April 3, 2006

**Re: Partial Sufficiency and Further Action Determination under
WAC 173-340-515(5) for the following Hazardous Waste Site:**

- Name: Northwest Pipeline Corp Mt. Vernon CS
- Address:, 15498 Lange Rd., Mount Vernon, WA 98273
- Facility/Site No.: 2684
- VCP No.: NW 1528

FIGURE MVCS-X1
PROPOSED REMEDIAL AREA PLAN
AOPC 6
MOUNT VERNON COMPRESSOR STATION

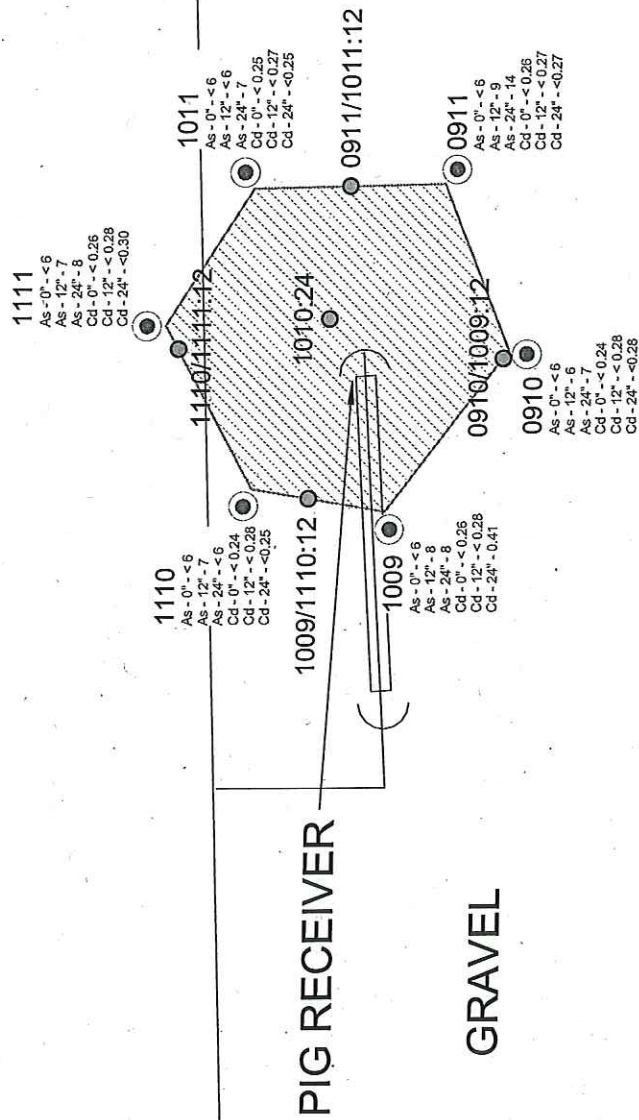
The remediation of arsenic (As) and cadmium (Cd) contamination within the area identified in the attachments to this letter, and in remediation plans as AOPC 6 meets the requirements set fourth in the Williams Capacity Replacement Joint FEIS/SEIS and in State Water Quality Certifications and permits as conditions that must be met prior to commencement of construction on the Capacity Replacement Project. Williams Pipeline has agreed to complete site remedial investigation and remediation at the remainder of the site after remedial actions necessary to allow CRP construction to proceed has been completed per the written schedule submitted to Ecology.
